Lower Thames Crossing

1.6 The Errata Report (Tracked changes version)

Planning Inspectorate Scheme Ref: TR010032
Application Document Ref: TR010032/APP/1.6

VERSION: **3.0**

Status	PINS SUBMISSION	Original Size	A3	Revision	P04
Application Document Number	TR010032/APP/6.5	Scale	1:22,000		
Drawing Title	Figure 24 - Location of the Noise Attenuation Measures - Construction				
Drawing Number	HE540039-CJV-EBD-SZP_EGNE0000000-DR-LE-60086

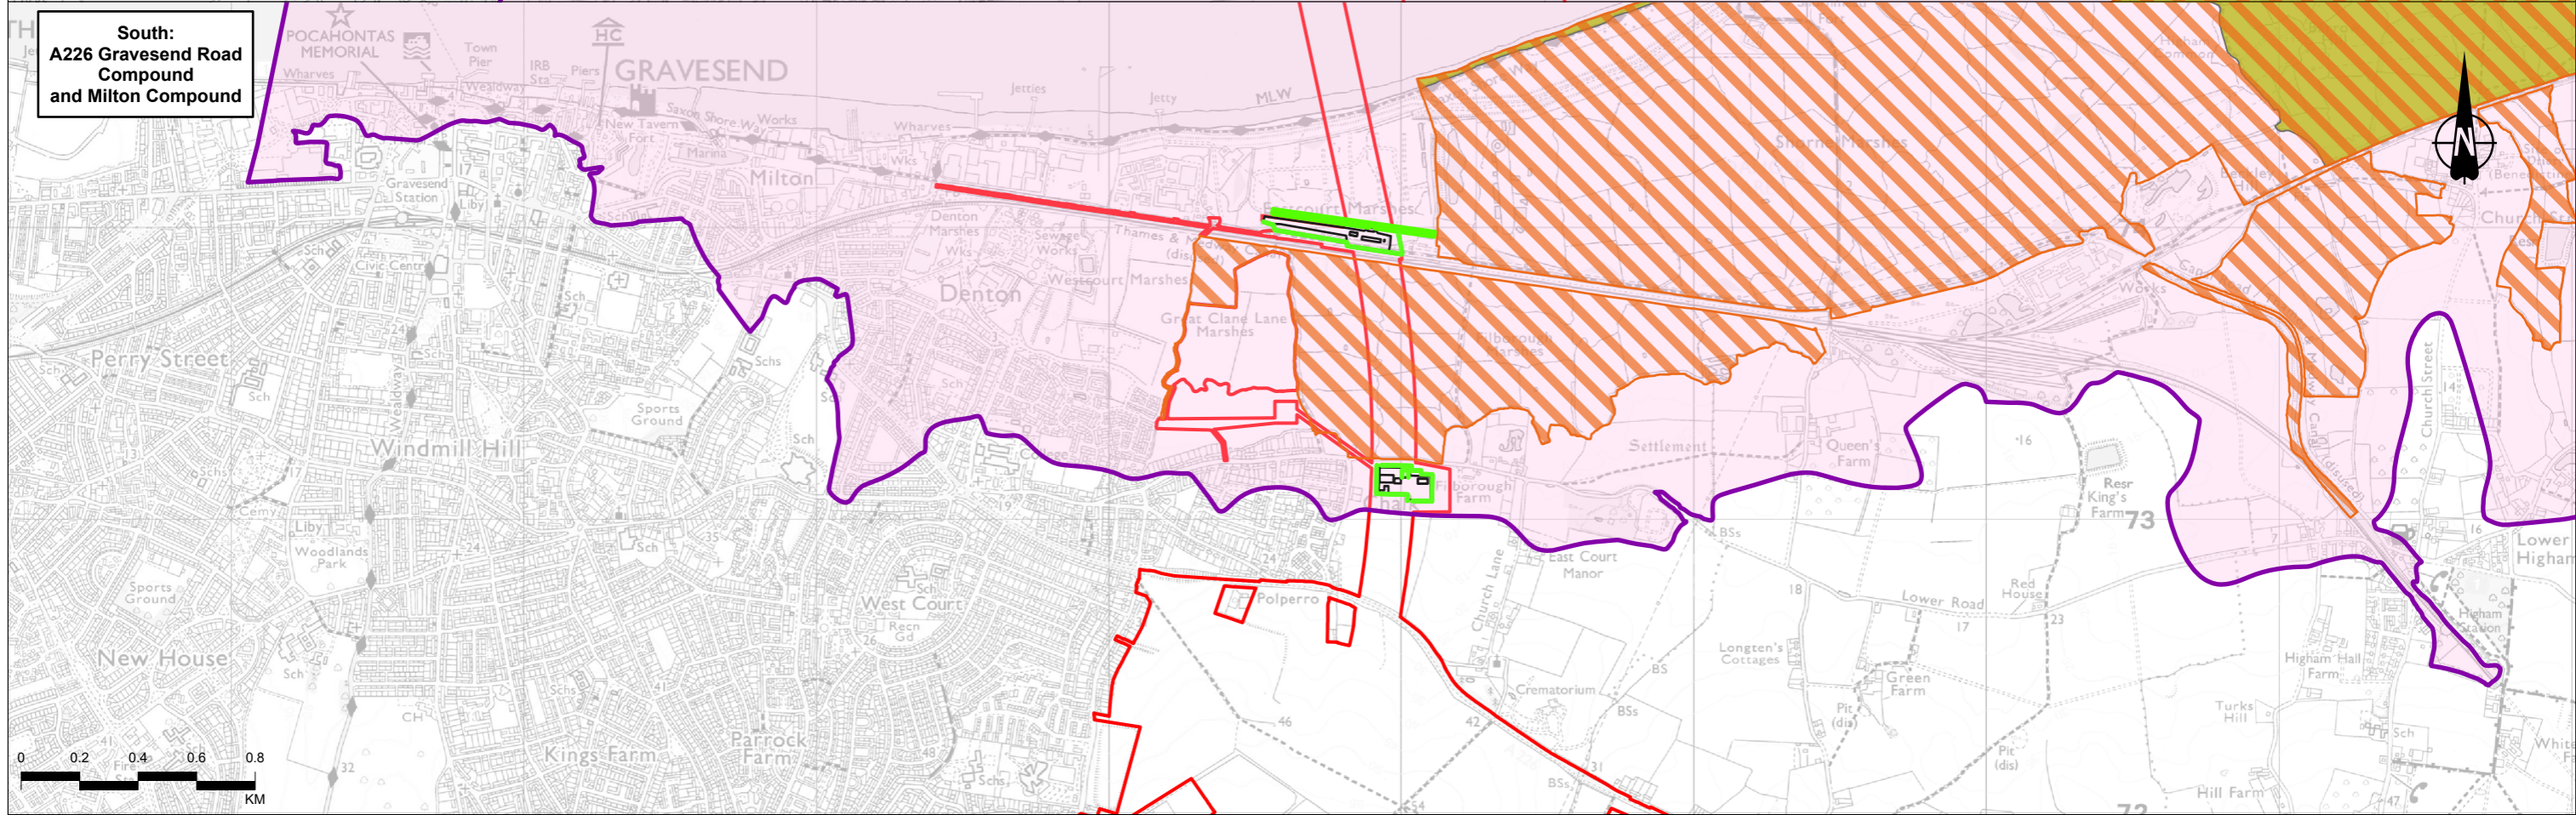
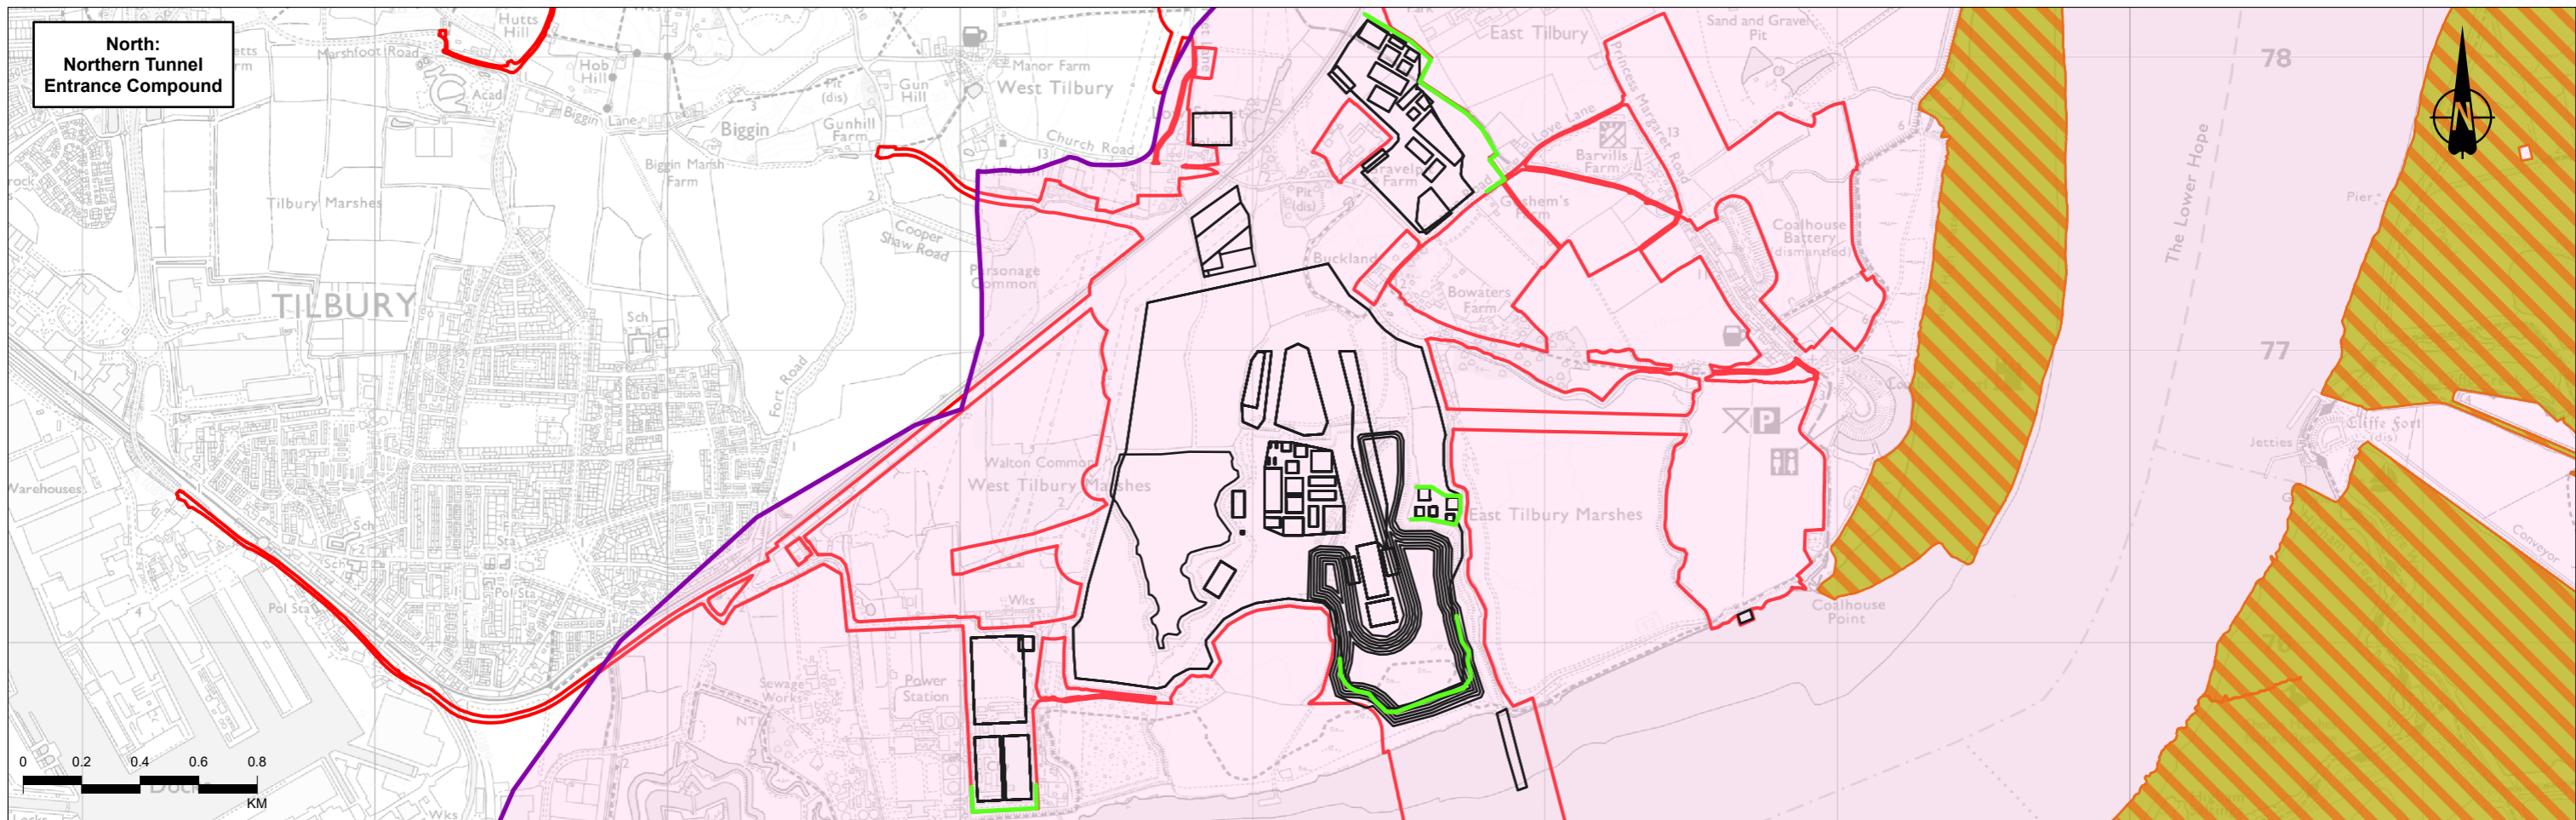
APP-487	D1	Habitats Regulations Assessment - Screening Report and Statement to Inform an Appropriate Assessment	Figure 24	Figure missing	Figure is cut off and does not include the full extent of proposed construction noise barriers	Figure updated and found in Appendix A of this document.
<u>APP-495</u>	<u>D3</u>	<u>Planning Statement</u>	<u>Paragraph 5.3.24</u>	<u>Typo</u>	<u>Paragraph says "model provision." Should state "modal provision."</u>	<u>No change. Document not updated at this time.</u>
